**RE: Fountain Hills Plaza Assisted Living
4551 Vista Fuente Rd. NW
Permanent C.O. - Accepted
Engineer's Certification Date: 1/6/22
Engineer's Stamp Date: 12/29/17
Hydrology File: C12D003B8**

DRAINAGE AND TRANSPORTATION INFORMATION SHEET (REV 6/2018)

Project Title: FOUNTAIN HILLS PLAZA ASSISTED LIVING **Building Permit #:** BP-2019-49252 **Hydrology File #:** C12D003B8
DRB#: 1003445-17DRB-70370 **EPC#:** _____ **Work Order#:** _____
Legal Description: LOT A-2-A, FOUNTAIN HILL PLAZA
City Address: 4551 VISTA VUENTE RD, NW

FOUNTAIN HILLS PLAZA ASSISTED LIVING
GRADING PLAN

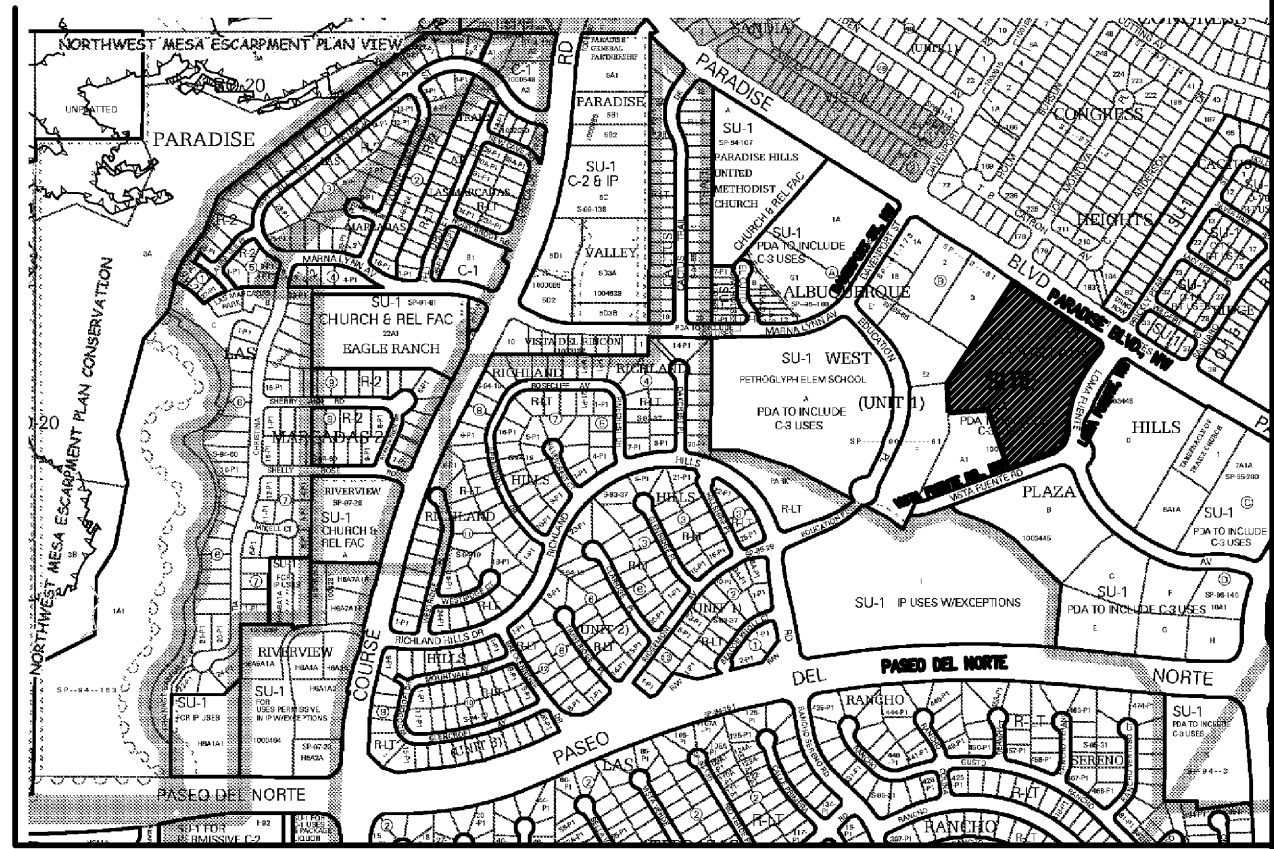
Attached please find a copy of the revised grading certification plan for the above referenced site with the changes highlighted. We apologize to not include all the changes originally. Below is the response to your comments dated 11-30-2021.

2) We had to reroute the storm drain pipe because during construction realized the pipe would come through the stem wall on the east side of building and would be in the air. Therefore, rerouted to the northeast corner and then into the pond. This is shown on the grading plan with a darker color and it's highlighted.

3) The changes are clouded with a number and explanation on each item.

1) The sidewalk to the south originally was shown straight, However, with the existing grade we were not able to accomplish the handicap accessibility. Therefore, we had to build it in the zigzag manner to get the correct grade. The pond that was in the pat, was moved a little east and lower. We also installed the riprap from the end of retaining wall to the new pond.

2) Somehow the sidewalk along north property line got missed during the preparation of the grading plan. This sidewalk was on the original approved site plan from DRB. I did not realize that sidewalk actually is not on the plan. This is shown on the as-built grading plan.

3) The sidewalk along the north side slopes to the north and all the water drains to the north of the sidewalk. I know there are not actual swale, but the grades does flow in that

direction (I have shown some spot elevation). We have installed a small pond with riprap to catch all the water. We also have installed two 4" pipe from this pond into the big pond. This is shown on the as-built plan.

4) Since all the water drains to the north of the sidewalk along the north side and installing two 4" pipe, there are very minimal flow affecting that slope with the riprap. Therefore we eliminated the riprap on that corner of the pond. We actually have installed riprap under each roof drain on the site and in the pond as well to eliminate the erosion in the pond.
